Brief Supporting the Motion for Six Material Actions to be completed by Sio Silica and Section 35 Indigenous Consultation to be held before continuation of CEC Hearing

**D. M. LeNeveu, M.Sc. Bsc.(hons. physics), B.Ed., former Member of Canadian Society of Safety Engineering
Oct. 20, 2022**

Figure 2. Drawing from Sio Silica airlift patent application.
Drawing was reproduced from the Sio Silica patent as reproduced on the project registry

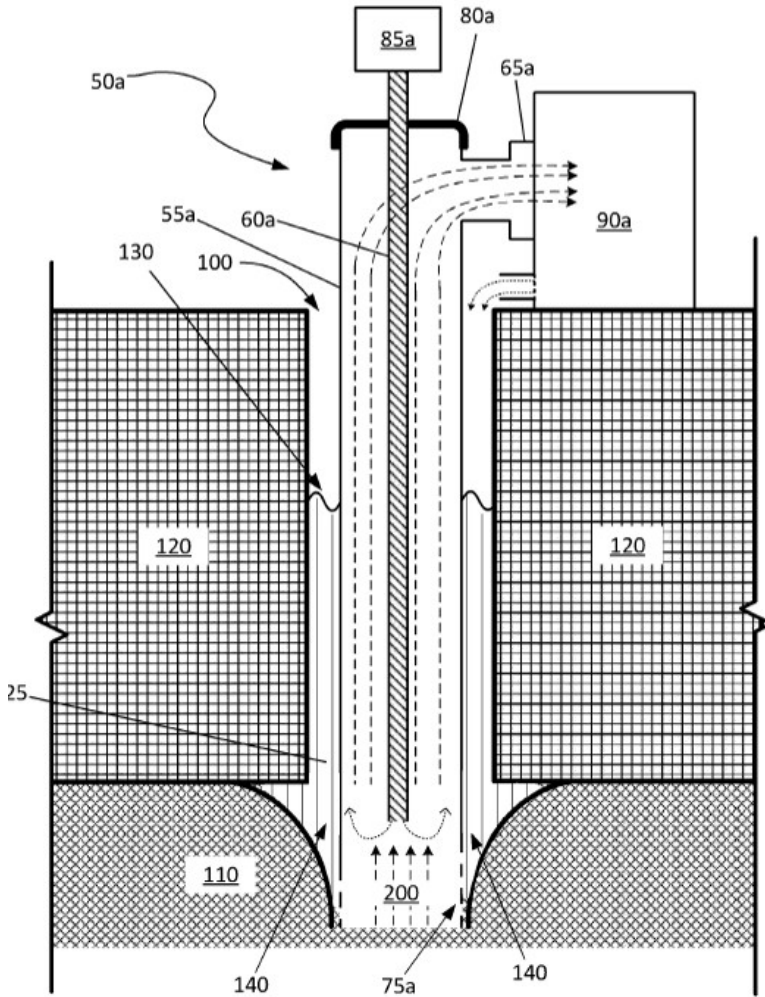
“In the present example a void 140 is formed and filled with water. It is to be appreciated as the void forms and sand moves away from the perforated wall 75a, the advantages of the perforated wall 75a are negated since the water may pass through the perforated wall. However in some examples the conduit 55a may be extended to maintain the perforated wall 75a below the sand to continue to receive the advantages of the perforated wall. Alternatively, the gas injection line 60a may be used to generate a pressure vibration or pulse air to agitate the sand such that the void 140 is partially filled by the settling of the sandstone formation 110a to cover the perforated wall 75a.”

The extension of the gas injection line to promote sand entering the water filled area around the production tube would introduce a large amount of air into the aquifer exacerbating the detrimental effects of oxidizing

conditions in the aquifer including promotion of microbial and fungal growth, precipitation of iron and manganese, and oxidation of sulphide sources leading to heavy metal release.

The movement of injected air in both aquifers and the pressure resulting from the re-injected air must be modeled. The modeling must determine the ability of the head drawdown from air lifting to enable sufficient water to re-enter the aquifer by gravity alone without exerting any extra injection pressure. The water re-entry must be sufficient such there is only 10 US gallons per minute net water loss per cluster as noted in the MSSAC/ KGS questions for clarification.

Figure 6. Acrylamide concentration in Sio Silica Slurry loop

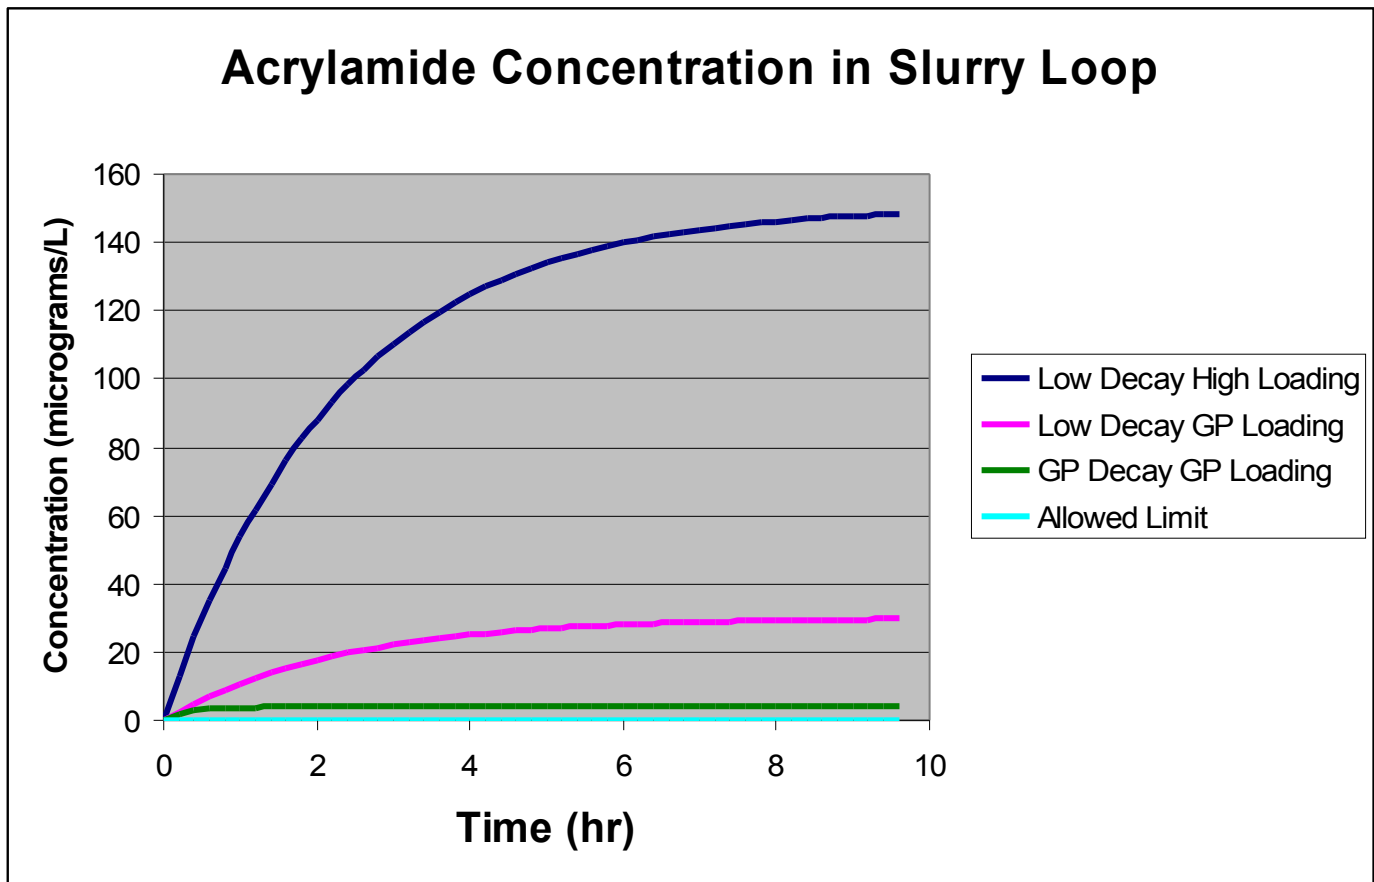
Figure 6 illustrates the acrylamide concentration would rise to steady state values above the allowed limit in the Sio Silica slurry loop in a matter of hours. “Loading” in the legend of figure 6 refers to the mass loading rate of the acrylamide monomer in the clarifier tank of the slurry loop. “GP” indicates Great Plains values.

The loading of the acrylamide monomer used here does not include degradation due to dissolved oxygen and Fe^{2+} as documented by Xiong et al., 2018¹⁰. Degradation would result in much higher dissolved toxic acrylamide concentrations.

Remediation by a contaminant removal process such as reverse osmosis would be required to operate continuously. Sio Silica must specify the volume, disposal method and disposal location of the concentrated waste stream for acrylamide removal.

Figure 7. Selenium concentration in the Sio Silica wash plant and slurry loop water

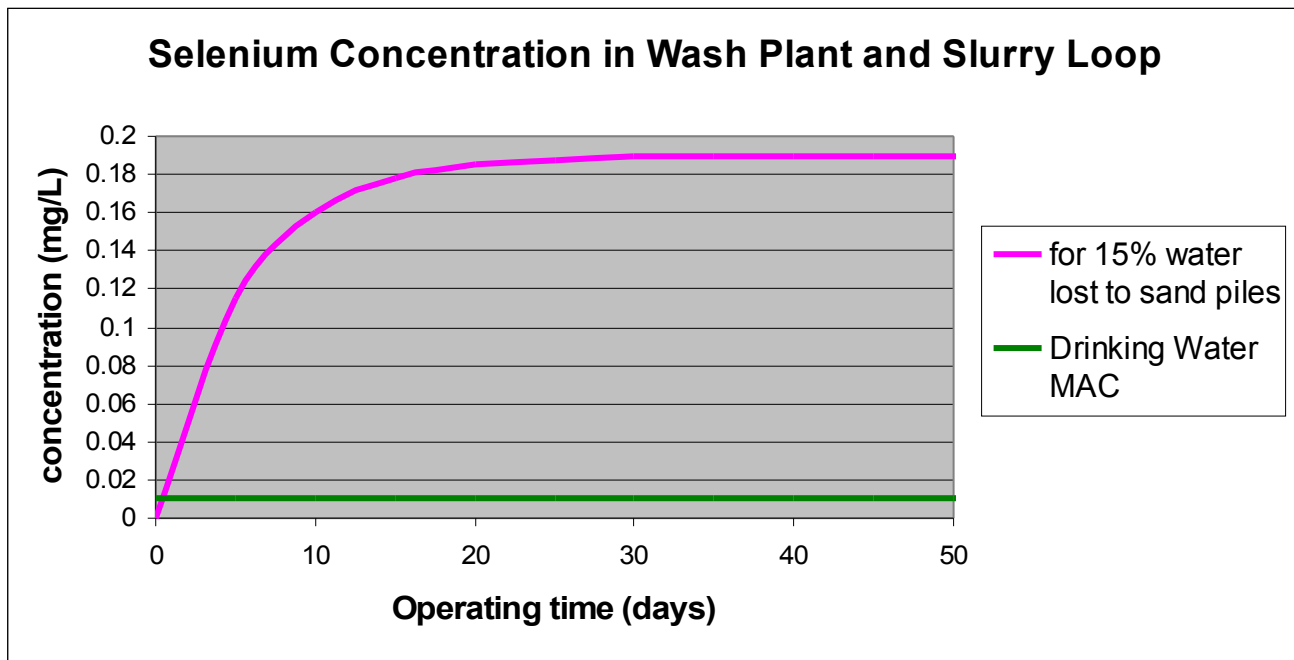
Figure 7 illustrates the selenium concentration in the slurry line loop as a function of time for a zero initial concentration of selenium in the water entering the slurry line, Q_L of 23.7 m³/hr, M_s of 4.41 g/hr and V_p of 1325 m³ for the water loss, Q_L , determined for 15% water loss to sand stockpiles.

Figure 7 illustrates that the selenium concentration would rise to steady state in the slurry loop and wash plant in about 20 days and would exceed drinking, irrigation and aquatic life water guidelines in a matter of hours. Remediation by a contaminant removal process such as reverse osmosis would be required to operate continuously. Sio Silica must specify the volume, disposal method and disposal location of the concentrated selenium waste stream.
